No.	QUESTIONS	RESPONSES
1.	Following the compulsory site inspection and discussions held on site, we respectfully request that the tender closing date be extended by one (1) week, from 7 October 2026 to 14 October 2026. This request is necessitated by several technical and pricing matters raised during the site inspection which require clarification and/or specialist input before we can submit an accurate and fully compliant tender: Timing of responses to tender queries: We understand that responses to queries are expected by 5 October 2026, while the tender closes on 7 October 2026. This provides only two days to assess the clarifications, obtain revised specialist quotations where necessary, amend our methodology and incorporate any resulting changes into our final pricing.	The request for extension has been granted to 14 October 2026. Refer to Addendum 1.

15.	The Bill of Quantities indicates demolition of concrete existing spillway toe, but this is not shown on the drawings. Please highlight/indicate the demolition of the existing spillway toe on the drawings?	Refer to DWG 9368-501  TYPICAL DEMOLITION SECTION SCALE 1:75

Refer to DWG 9368-501

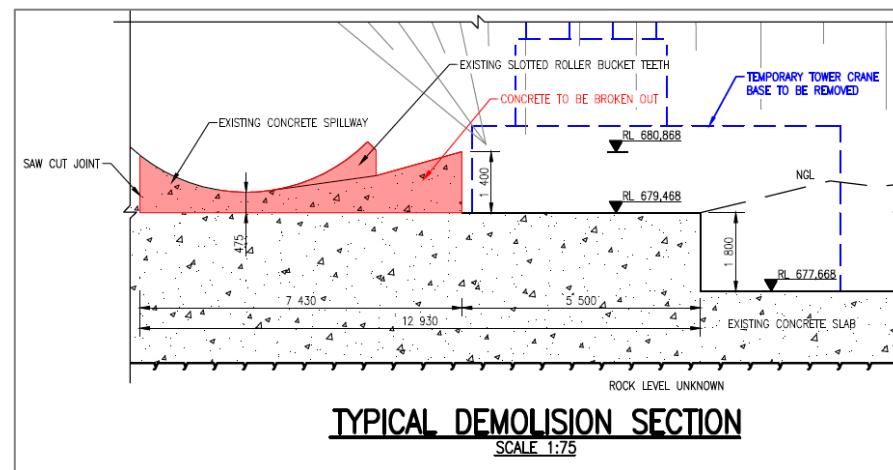
16. The Bill of Quantities indicates demolition of stilling basin roller bucket, but this is not shown on the drawings. Please confirm that the stilling basin roller bucket is the portion highlighted in green on the extract below?

SECTION 05-05
SCALE 1:50

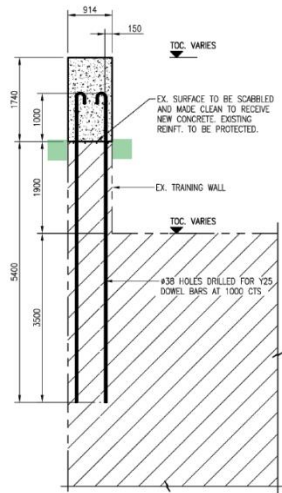
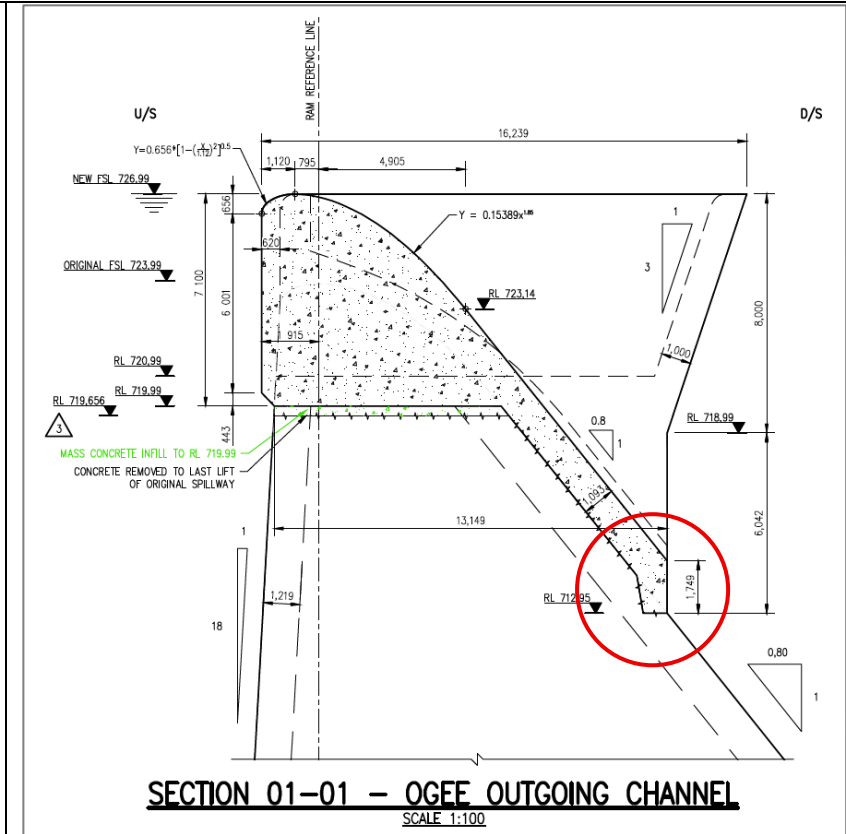
17. During the site inspection it was mentioned that there are cantilevers on the training walls that must be demolished although this is not indicated in the Bill of Quantities or on the drawings. Please confirm if these are the cantilevers as highlighted in green on section 05-05 below? Please confirm the quantity of these demolitions?

The BoQ will be revised to include cantilever.

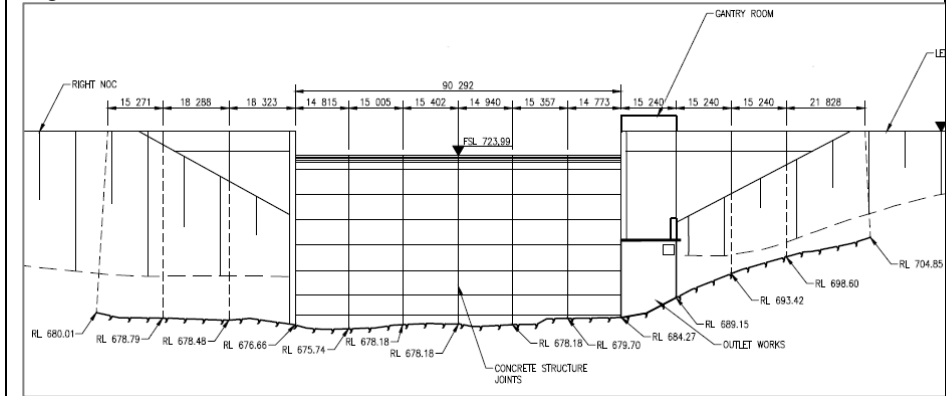
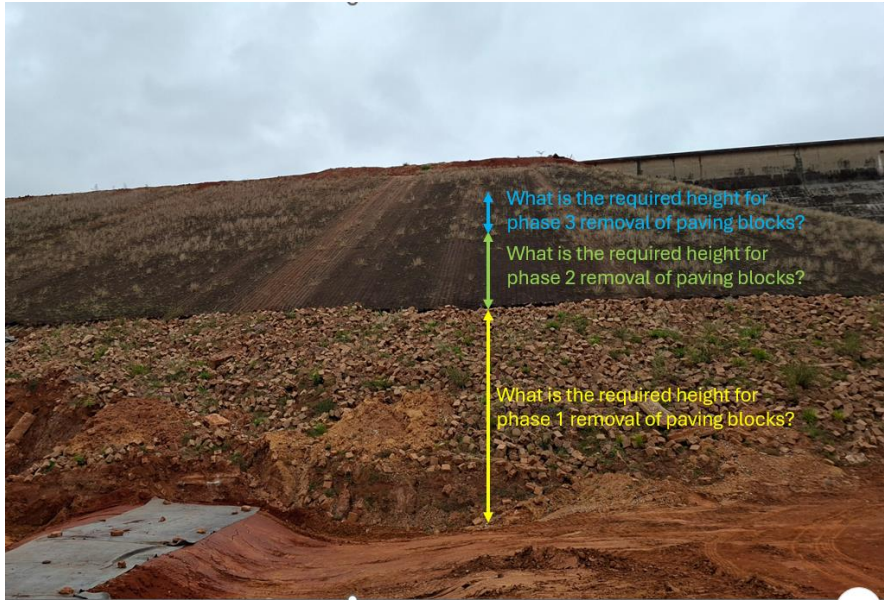
19. Please confirm the length of the spillway, left- and right NOC, left- and right banks not indicated on the drawings?

Spillway length – ± 90 m
Tongue walls – ± 53 m each (left and right bank)
Left embankment - ± 200 m
Right embankment – ± 720 m

Figure 1: Crane 1 Loads (Right Bank)

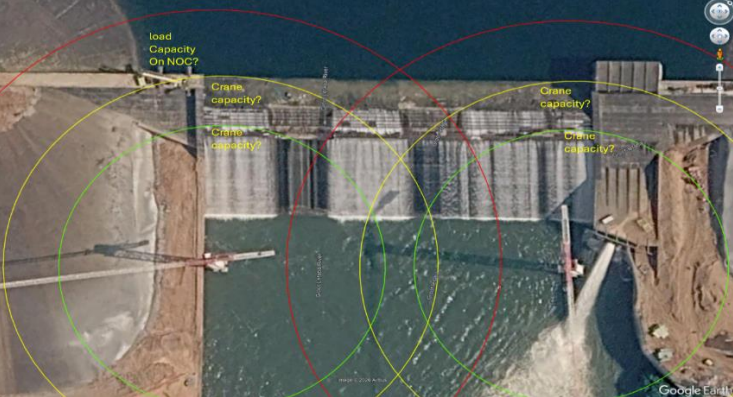
23. Please provide a **load contour layout** of the 2 construction cranes in relation to the dam wall indicating the crane capacity at different radii – refer to aerial photo below;

In-service Crane Loads for 65m Jib No. 8 tower section TS21 22.6 (No wind)					
Hook Height [m]	H [kN]	V [kN]	M [kNm]	R1 [kN]	R2 [kN]
49.5	6	-755	1591	-780	403
In-service Crane Loads for 65m Jib No. 8 tower section TS21 22.6 (Tail wind 72 KM/H)					
Hook Height [m]	H [kN]	V [kN]	M [kNm]	R1 [kN]	R2 [kN]
49.5	32	-755	2496	-1117	740
Out-of-Service Crane Loads for 65m Jib No. 8 tower section TS21 22.6 (Tail wind 151 KM/H)					
Hook Height [m]	H [kN]	V [kN]	M [kNm]	R1 [kN]	R2 [kN]
49.5	108	-658	3052	-1300	971

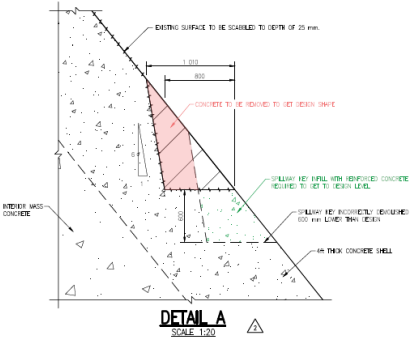
24.	Please confirm the load capacity on the right NOC for the purpose of mobile crane and excavator access – refer to aerial photo below; 	The space indicated on the NOC is limited ($\pm 2.7\text{m}$ wide) where it might be difficult for the mobile crane to fully extend its outriggers.
